**Mekong River Commission Secretariat**

**Procedures for Notification, Prior Consultation and Agreement (PNPCA)  
Proposed Xayaburi Dam Project – Mekong River**

## **PRIOR CONSULTATION PROJECT REVIEW REPORT**

24 March 2011

**Figure 2: Overall layout of Xayaburi dam project (Layout Report, 2010). The structure is 820 m long and 32.6 m high. The spillway facility comprises ten radial gates, 19 m wide and 21 m high. Gross reservoir volume is 1,300 m<sup>3</sup> or 1.3 km<sup>3</sup>**

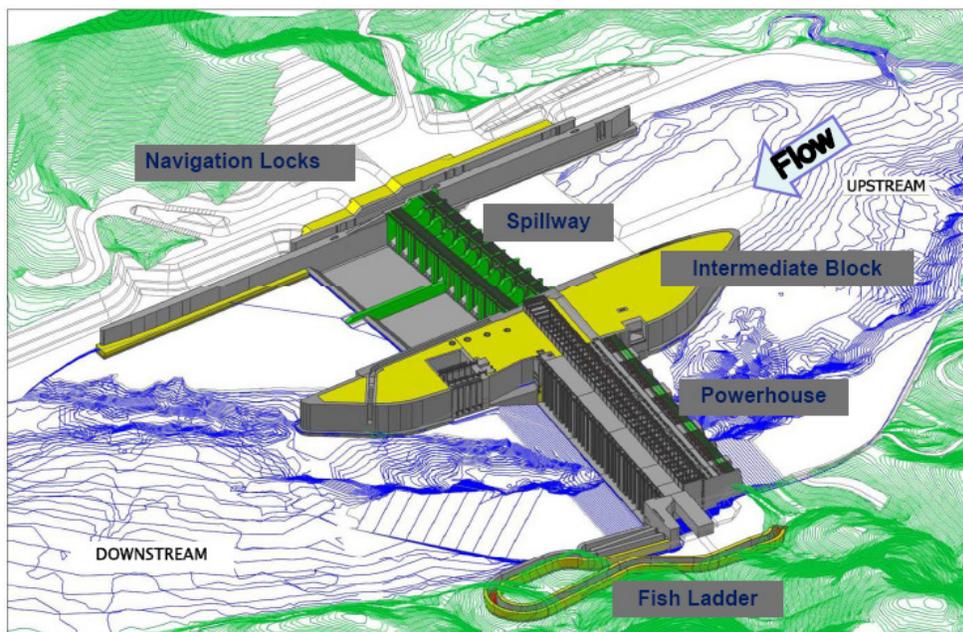
Based on an independent review conducted by MRCS, the general layout of the project appears consistent with the site conditions and the required facilities. The arrangement has been selected following evaluation of costs and benefits of alternatives. The range of alternatives evaluated in the Feasibility Study appears logical and consistent with conventional hydropower and dams design practice. The project layout derived in the Feasibility Study was adopted for preparation of the Project Design Report, which forms the basis for the EPC contract for project construction.

**Figure 4: Spillway cross section.**

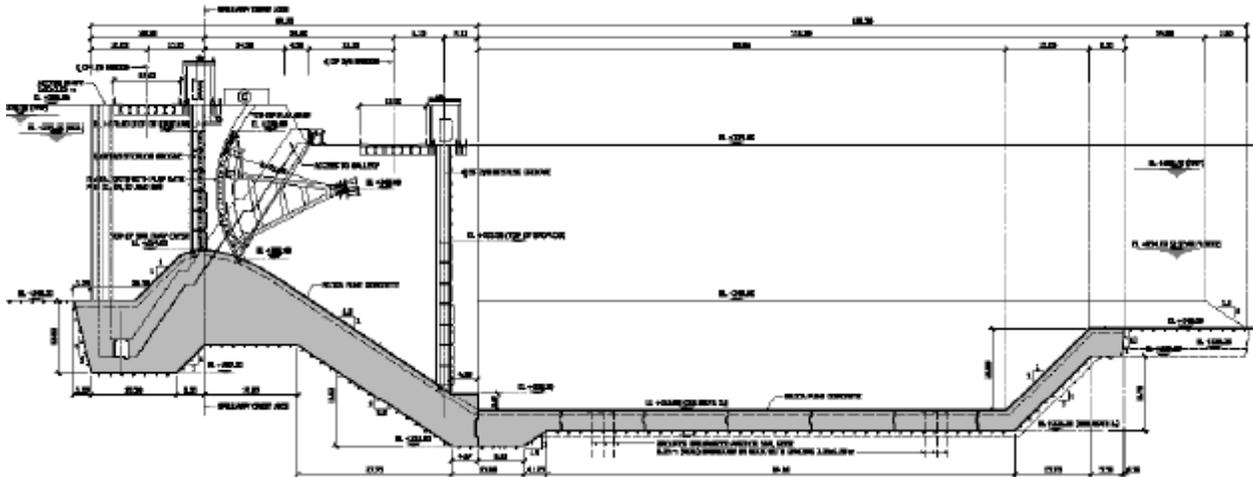
The arrangement of the spillway (see **Figure 4**) does not provide low-level discharge capacity as suggested in the Preliminary Design Guidance. The spillway has a common crest level at elevation 254 m for all of the gates. An alternative design arrangement with some of the spillway gates arranged as low-level sluices is possible if improved reservoir flushing is required.

The use of low-level sluices would also offer the significant benefit of lowering the upstream water level during the period when the powerhouse cofferdams are constructed. With the present design, the cofferdams must be closed with water flowing over the crest of the spillway, resulting in high velocity through the closure section.

**Figure 5: First phase of construction proposed in the design documents**

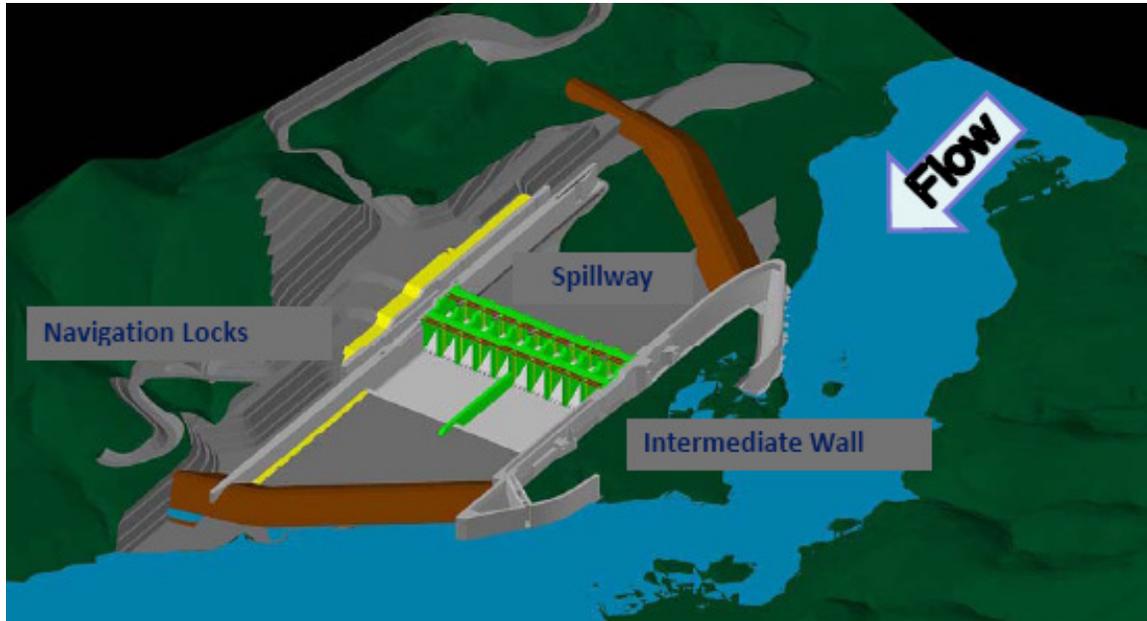
**Review recommendation:** Detailed design studies are required to confirm that the changes in flow velocity during this period will not affect these in-stream uses,

**Figure 6: Second phase of construction proposed in the design documents**

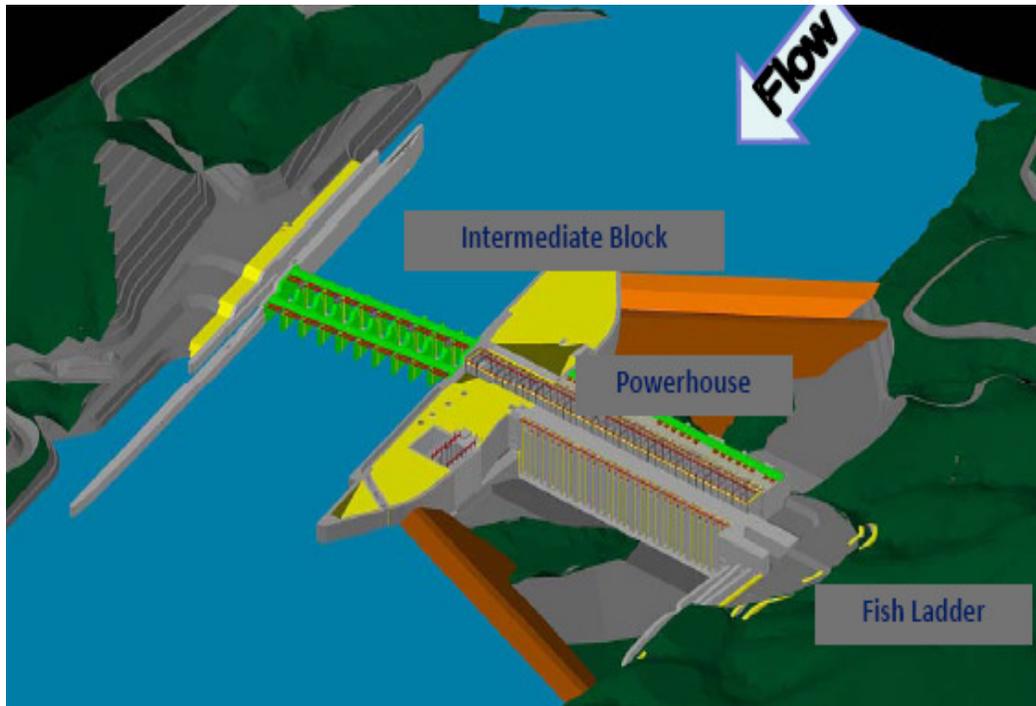
The time periods assigned for construction appear reasonable as a basis for preliminary planning. Opportunities for some reduction in the construction period could be devised during detailed construction planning.

Figure 8: Fisheries Expert Group recommendations for adapting the fish bypass design at Xayaburi dam.

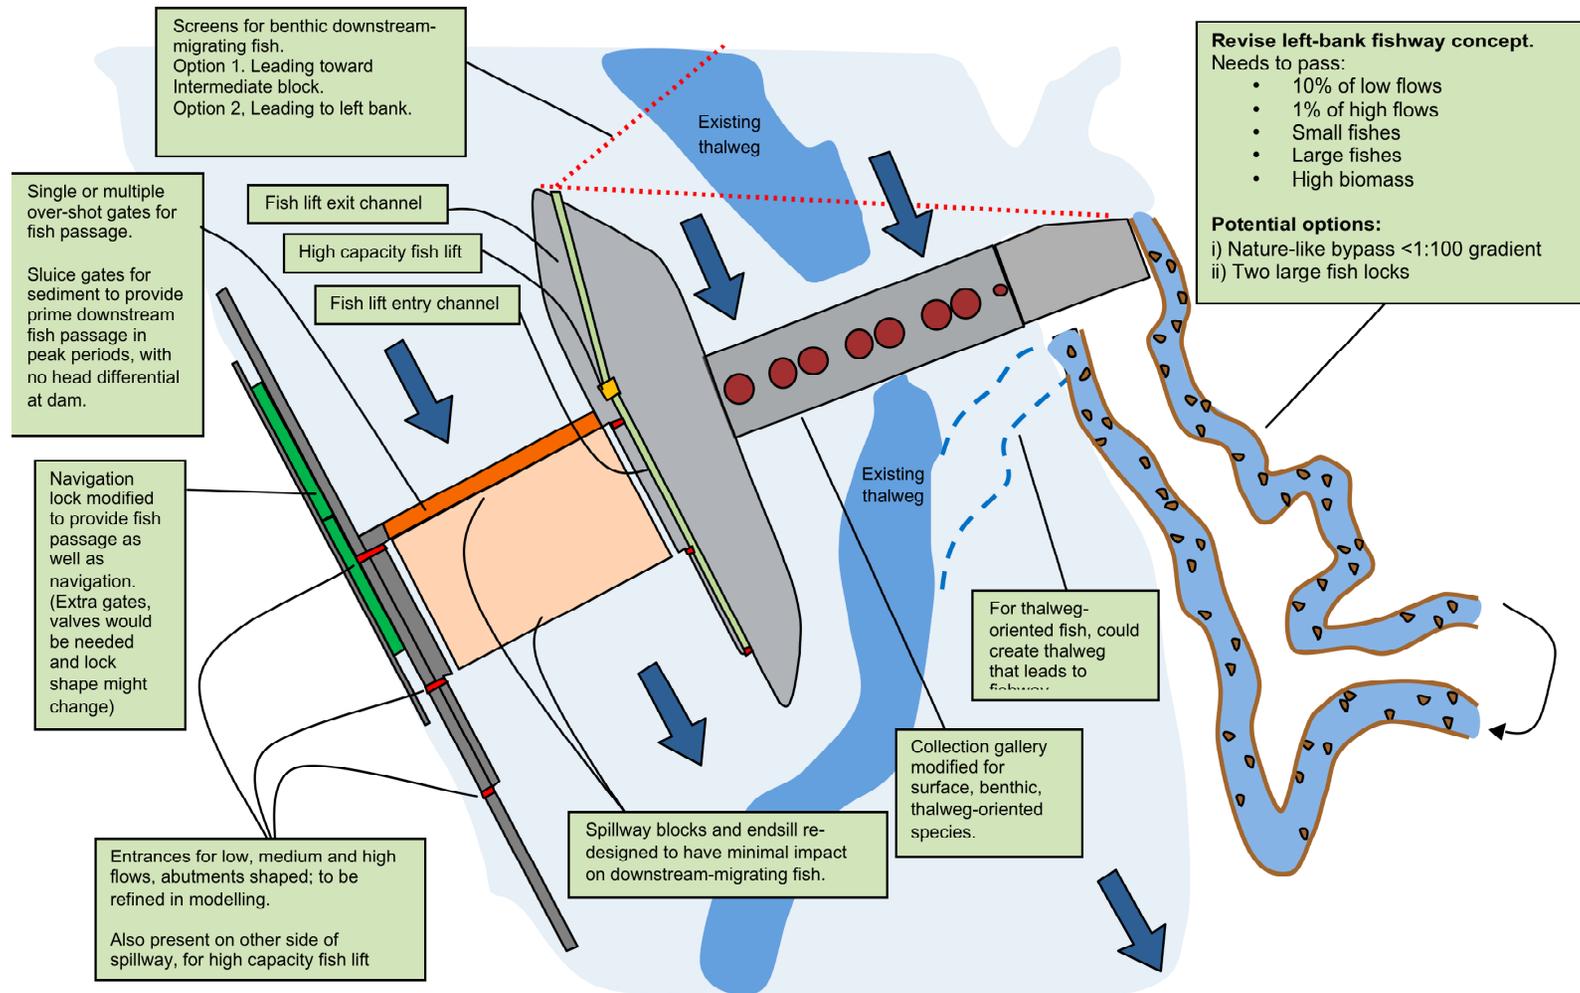
- Revise left-bank fishway concept to pass sufficient flow for the pass to function under different flows with sufficient space for large-bodied fish and high biomass, and maximum water velocities of 1.4 m/s and turbulence less than 30 W/m<sup>3</sup> for the passage of small-bodied fish. Potential options are a nature-like bypass on a low gradient (< 1:100), which will potentially allow upstream migration of Mekong giant catfish, or two large fish locks.

- Add solutions for mid-water, benthic and thalweg migrating fishes, including a benthic collection gallery underneath the draft tubes, or vertical slots between the draft tubes.

- Modify the navigation lock to provide fish passage as well as navigation. Add gates, valves and possibly multiple entrances for low, medium and high flows.

- Use physical and 2d/3d CFD model to optimise screens. Screen spacing of 2 cm is required.
- Provide one or multiple overshot gates on the spillway for fish passage.

An outline proposal for the type of design that should be provided is given in **Figure 8**.

**Figure 10: Pressure flushing to remove localized sediment deposits**

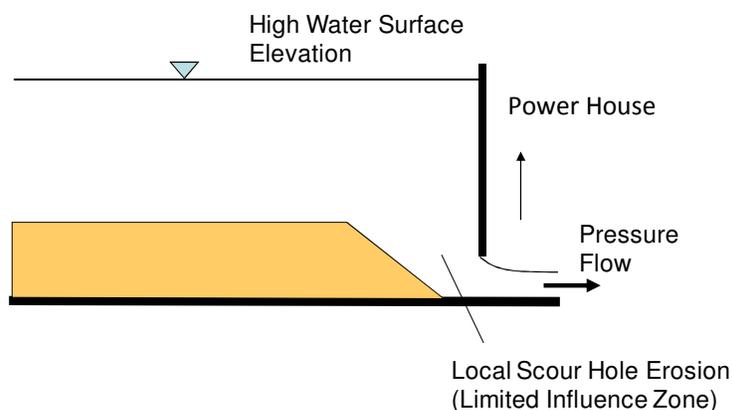
The project expects that sediment will accumulate in front of the power intakes and suggests using low level conduits to pressure flush sediment through the dam.

The Sediment Expert Group (SEG) concludes that this should be possible through pressure flushing, which is performed by maintaining a high water surface elevation while releasing water through the low-level outlets (**Figure 10**). Experience from many other dams demonstrates that pressure flushing will remove localized deposits from close to the powerhouse and not have an effect on sediment depositions more generally within the reservoir.

**Figure 11: Concept of operating the project to route sediment through the dam during periods of high sediment concentration**

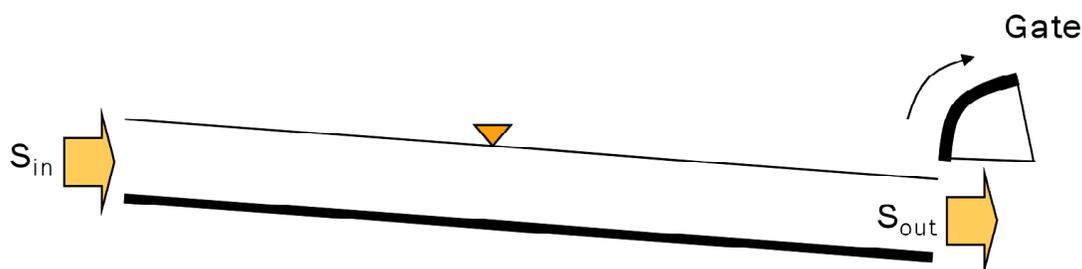
The review concludes that **Sediment Routing** is feasible at Xayaburi and that, if the spillway gates as currently designed were opened completely during high flow events with high sediment concentrations, it might be possible to generate sufficient transport capacity throughout the reservoir to pass a substantial proportion of the incoming sediment without its ever settling in the reservoir (**Figure 11**).

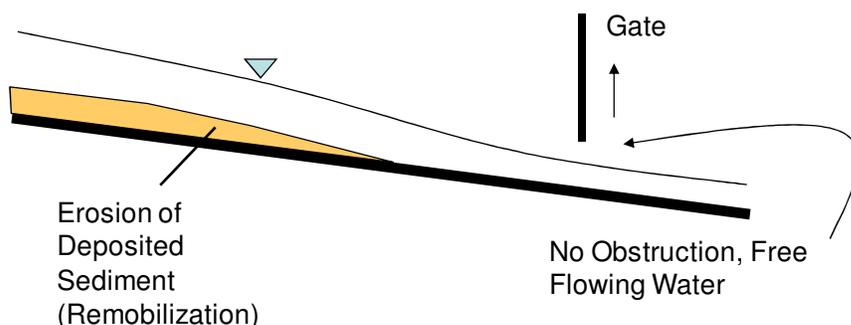
**Sediment flushing** requires operators to draw the water level at the dam down and increase the water surface slope through the reservoir, creating river-like flow conditions that re-suspend previously deposited sediment from the bed and banks and carry it downstream of the dam through the low-level outlets (**Figure 12**).

Sediment concentrations would be unnaturally high during flushing and so it would be essential to comply with the advice provided by fisheries and environmental experts to avoid adverse impacts on fish and wildlife. It would not be possible to generate hydropower during flushing operations, because the water level for flushing under free flow conditions would normally be below the minimum elevation of 268 m.a.s.l. for energy production, and otherwise the aim is to avoid heavy sediment concentrations moving through turbines during flushing operations.
